## ***Interactive comment on “Identification and classification of urban micro-vulnerabilities in tsunami evacuation routes for the city of Iquique, Chile” by Gonzalo Álvarez et al.***

**Gonzalo Álvarez et al.**

Received and published: 22 May 2018

**Fig. 1.** Added figure to summarize the methodology

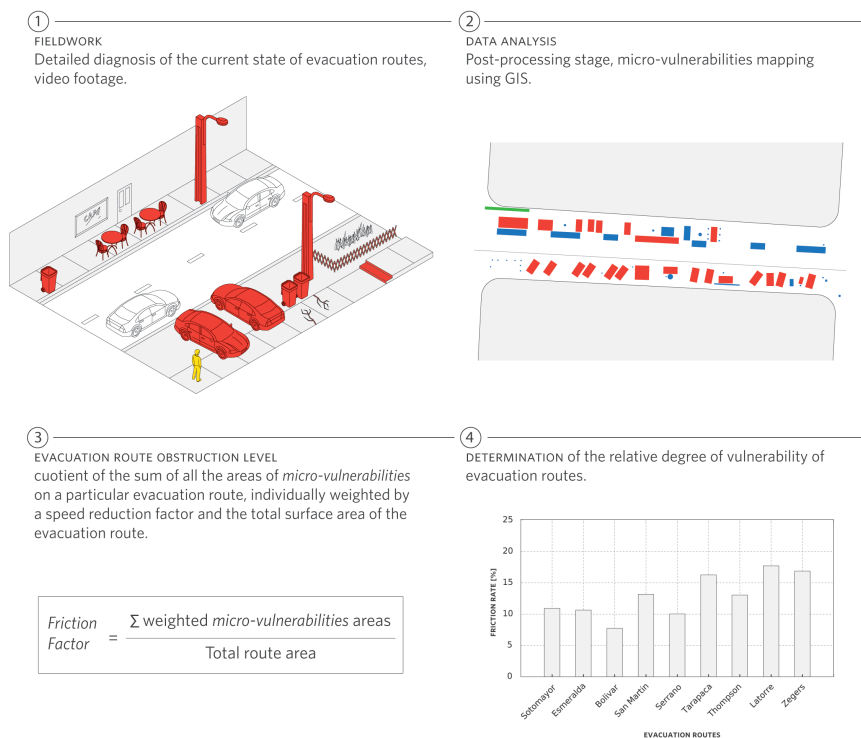
3) "In the Data analysis Section, two different classifications of the elements found in the evacuation routes are described. The first classification, based on (i) blockages, (ii) level changes, and (iii) surface roughness, seems a bit disconnected to the method described in pages 8-9. Only after reading the next section on friction rates (pages 10-11) the role of this classification is understood. It would be advisable to mention in page 8, lines 5-7, that this classification is used later for the calculation of the friction rates"

Dr. León has already replied to this comment, which we acknowledge. In order to facilitate the reading of the article, we have deleted the following phrase which appeared at the end of the first paragraph of subsection 4.2, and included an additional Figure (Figure 2 in the revised manuscript) which summarized the different steps of the methodology that is described in section 4.
